DeKalb County Department of Planning & Sustainability

STAFF ANALYSIS

Case No.: CZ-22-1245934 **Agenda #:** D6

Request: To modify zoning conditions to remove condition #1 pursuant to CZ-06-1241 restricting the use of the property to office and retail uses to allow a drive-through car wash in the C-1 (Local Commercial) zoning district.

DRAWING TITLES	
SITE PLAN	
PROJECT NAME:	MODWASH 1849 LAWRENCEVILLE HWY, DECATUR, GEORGIA
CLIENT:	HUTTON 738 CHERRY STREET, CHATTANOOGA, TENNESSEE 37402

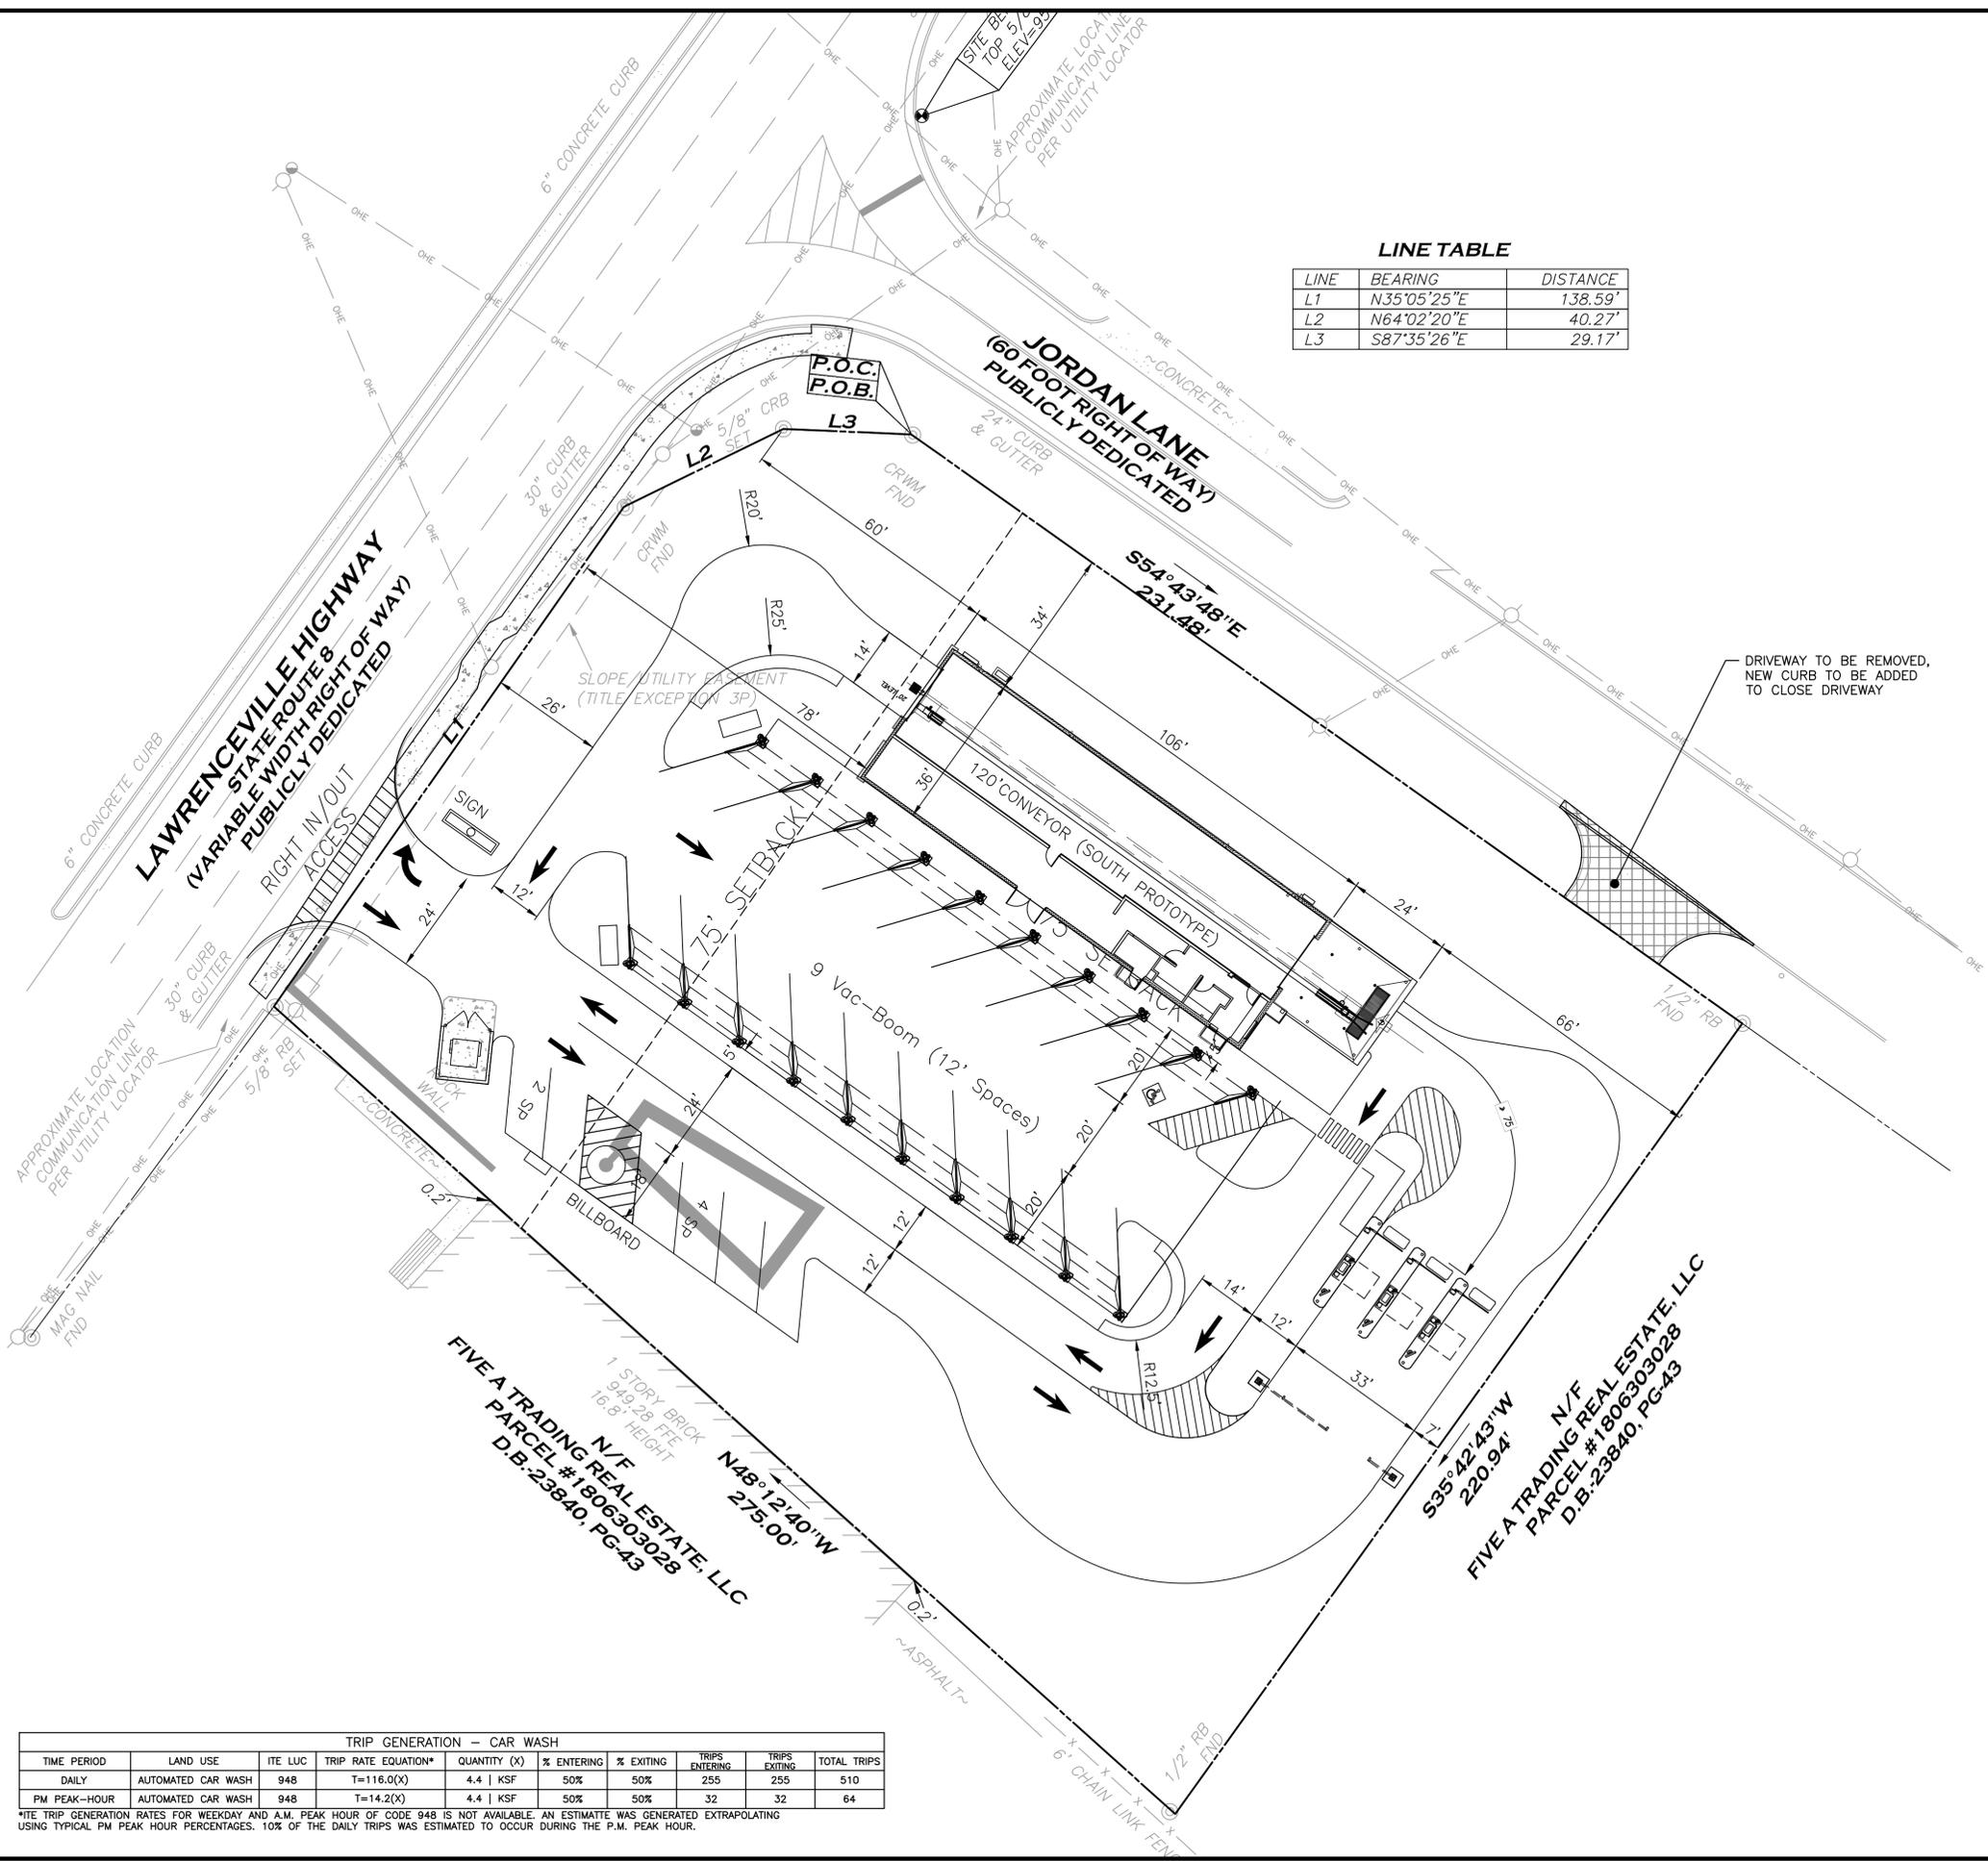
N18. CZ-22-1245934 - Lawrenceville Hwy is a State Route. GDOT review and approval needed prior to Land Development Permit. (MWilson@dot.ga.gov). Lawrenceville Hwy is classified as a major arterial. The following minimum infrastructure requirements must be met: Right of way dedication of 50 feet from centerline OR such that all public infrastructure is within county right of way, whichever greater, a 6 foot sidewalk (Zoning Code) with a 4 foot bike lane (Land Development Code) OR a 10 foot shared multiuse path (preferred) located 5 feet from back of curb, Pedestrian Scale Street lighting required (Contact Street Light Engineer, Herman Fowler: hefowler@dekalbcountyga.gov), 11 foot travel lanes with curb and gutter. Jordan Lane is classified as a local road. The following minimum requirements must be met: Right of way dedication of 27.5 feet from centerline, 12 foot travel lane from centerline with curb & gutter, a five foot planting strip and a 5 foot sidewalk (Zoning Code), Pedestrian Scale Street lighting required (Contact Street Light Engineer, Herman Fowler: hefowler@dekalbcountyga.gov). Add pedestrian crossing and ADA ramps to the intersection of Jordan Lane at Lawrenceville Hwy.

Conceptual plan doesn't indicate the location of the stormwater management facility. Location of stormwater management shall be shown or compliance with the County stormwater management regulations shall be explained.

Additional consideration must be given to the 10% downstream analysis.

Runoff Reduction Volume shall be provided, unless technical justification is provided in regard to the unfeasibility. Strongly recommend investigating the site and identify location where RRv can be provided and re-design/revise the layout to comply with the RRv requirement.
